## Contract T.3733

### Contract: Watermain Replacement - No. 3 Road from Cook Road to Granville Avenue

**Re: Contract T.3733  
Addendum No. 1  
Watermain Replacement - No.3 Road from Cook Road to Granville Avenue**

## TYPICAL TRENCH DETAIL

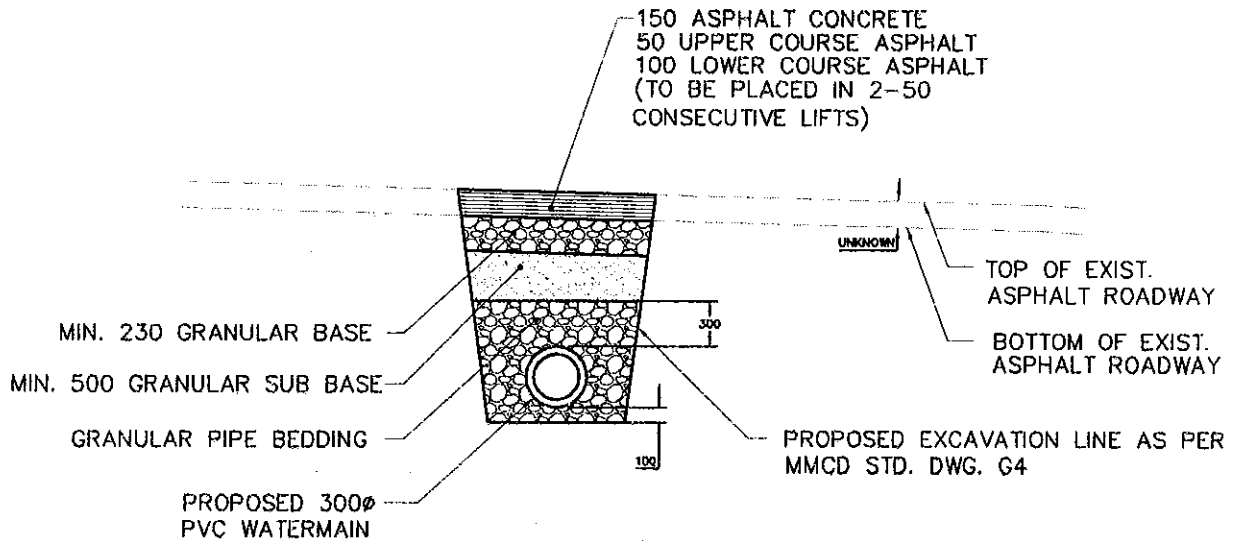
3.1.1. Replace the typical trench detail shown on the drawing Wc-955 sheet. 4 of 7 with the typical trench detail shown on the attached drawing Wc-955 Watermain Construction No. 3 Road (East Side) from Granville Avenue to Westminster Hwy Addendum No.1.

**A.** The Contractor is responsible for the full depth initial asphalt restoration as per typical trench detail attached to this Addendum No.1. The final mill & overlay to be done by others.
